CITY OF CLEVELAND

Cleveland City Planning Commission

February 20, 2026

Agenda: February 20, 2026

Incorporate One-way Pair Design

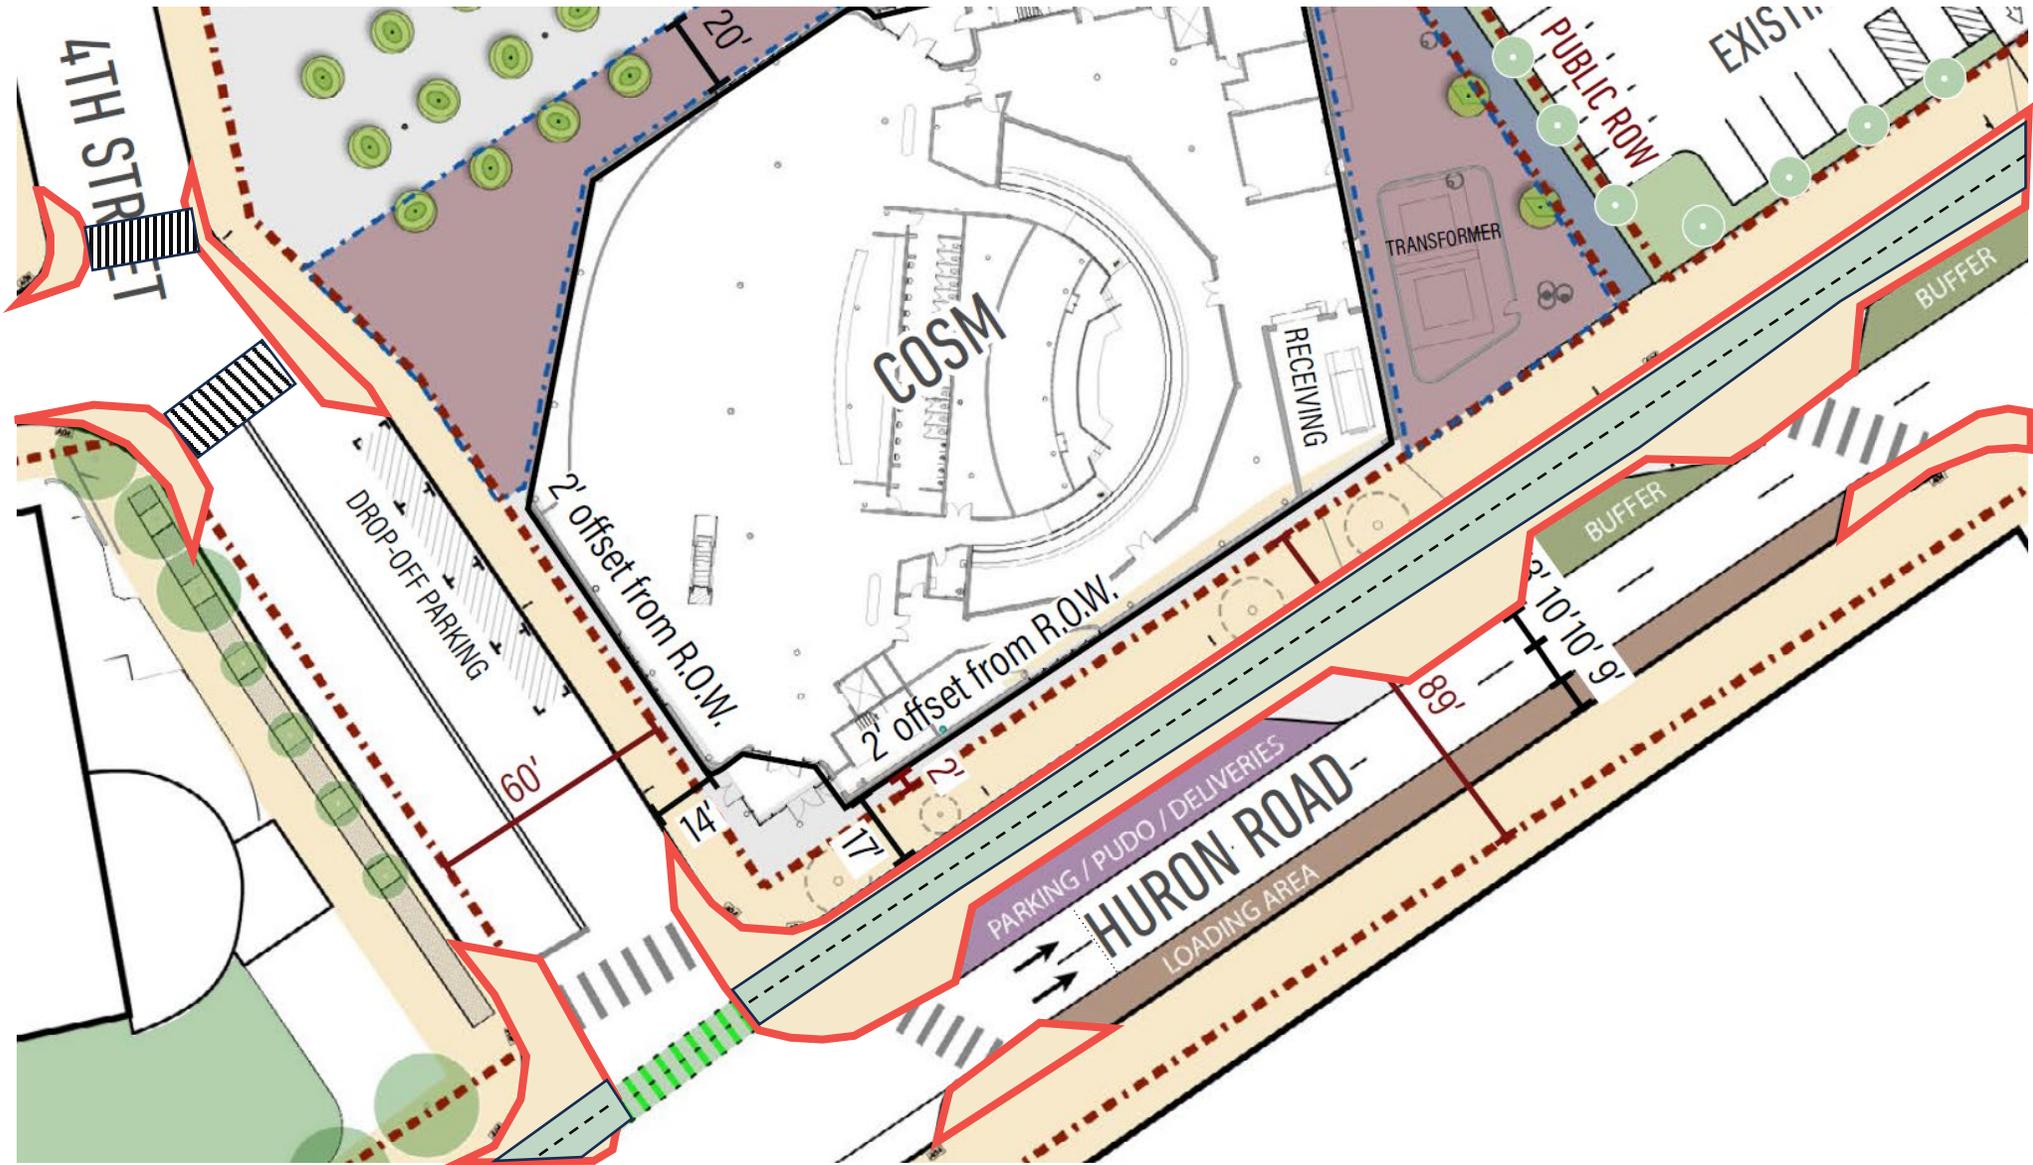
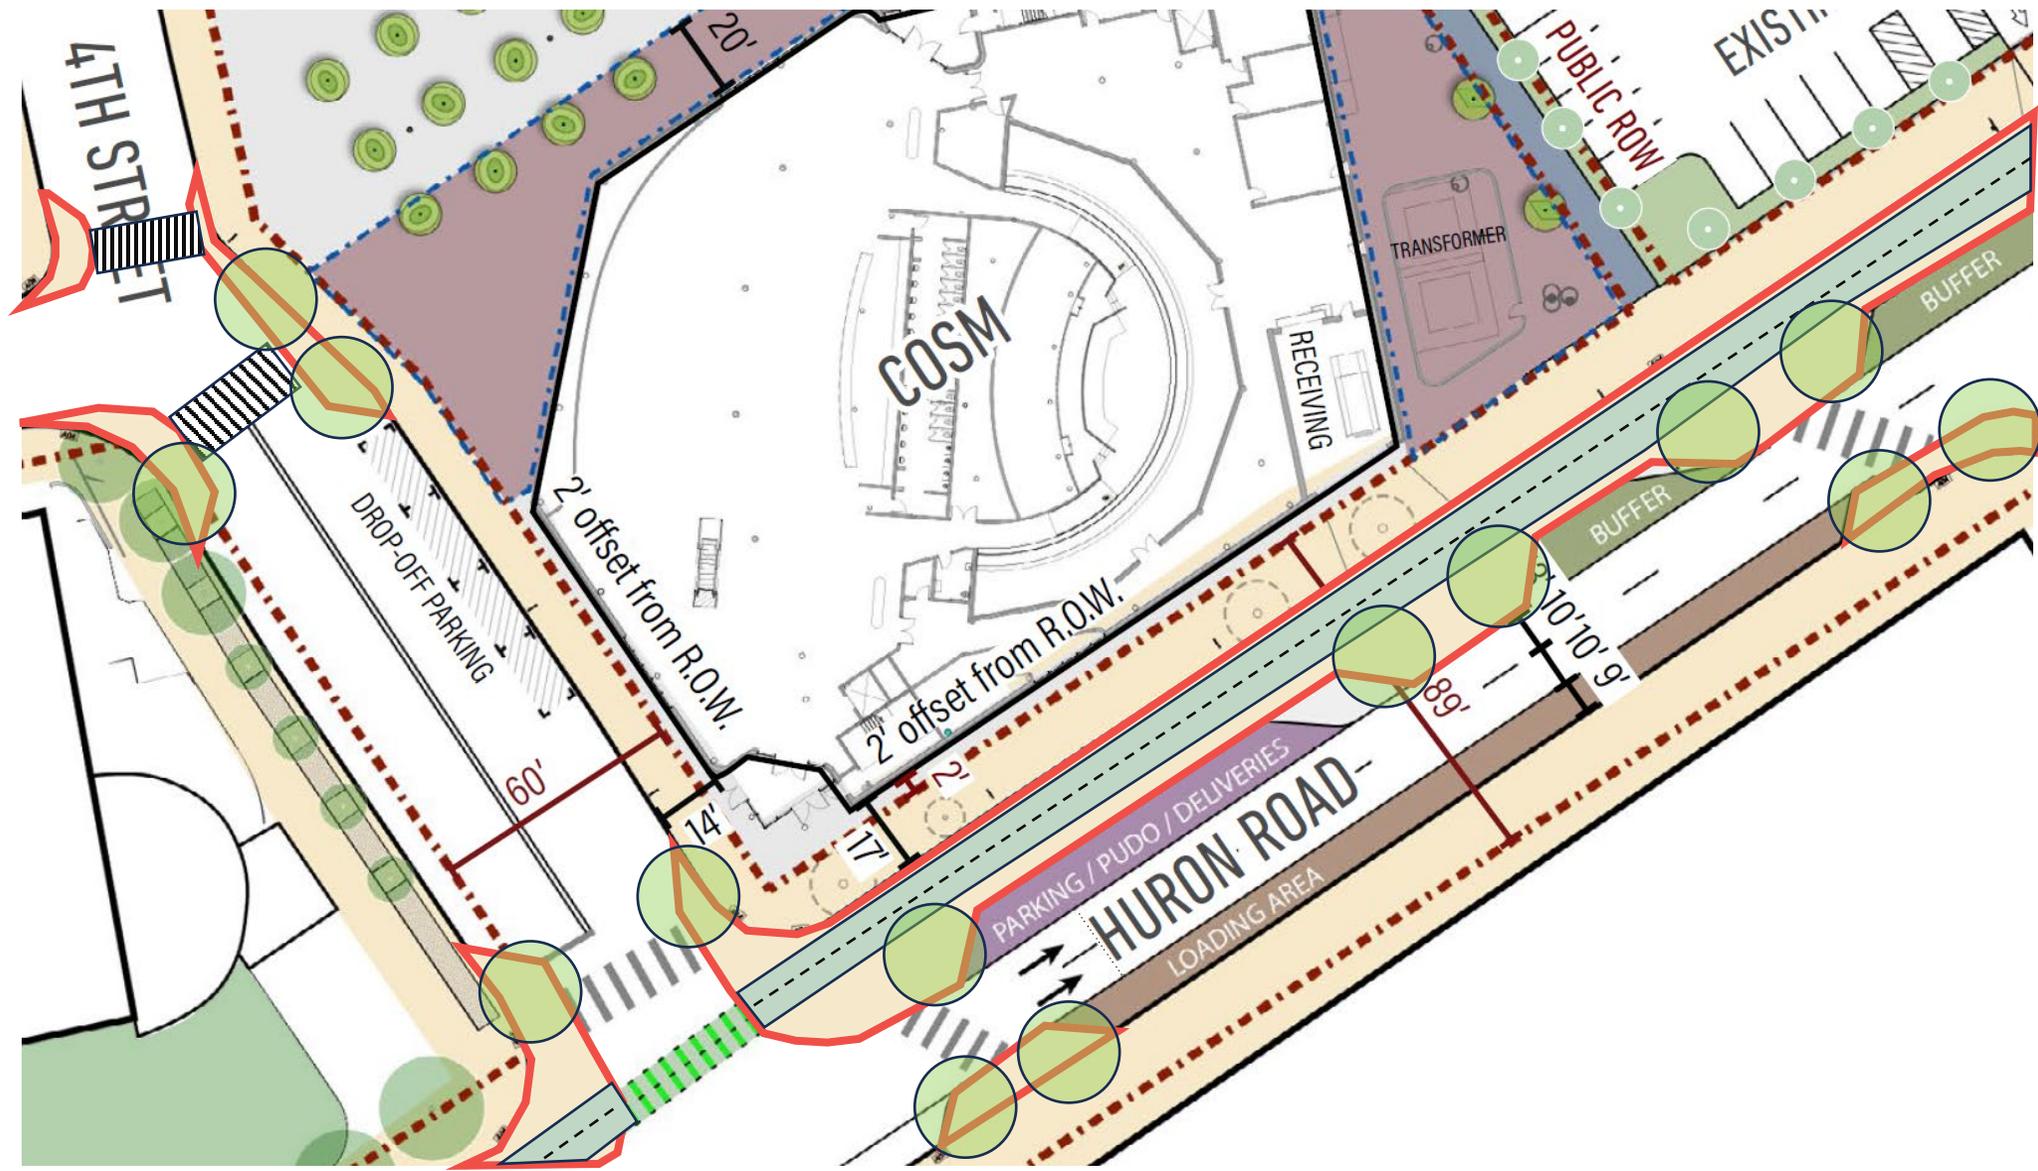
**Grander
Entry**

**Wider
Sidewalks**

**Safer
Crossings**

Increase Landscaped Spaces & Tree Canopy
